**MN Department of Labor and Industry,
Construction Codes and Licensing Division**

2025 Residential Energy Code Technical Advisory Group

**Code Change Proposal Compilation for the
Review of **ASHRAE 90.1-2022****

CODE CHANGE PROPOSAL FORM

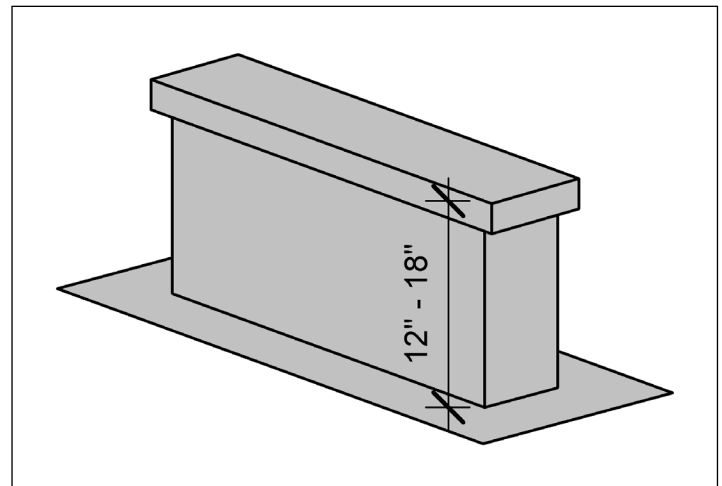
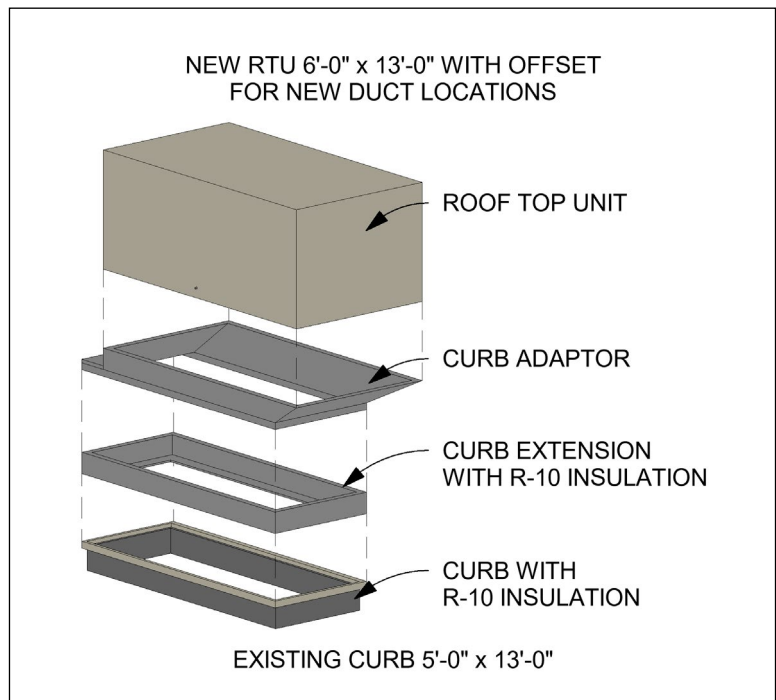
If the existing curb is tall enough to accommodate the installation of additional roof insulation, does the curb still need to be replaced?

No. If the curb height is tall enough to accommodate the required above-the-deck insulation based on climate zone, the intent to provide room for future additional roof insulation has been met. However, the existing curb must be insulated to a minimum of R-10. If R-10 cannot be accomplished, then it will need to be replaced with a curb meeting the minimum insulation value.
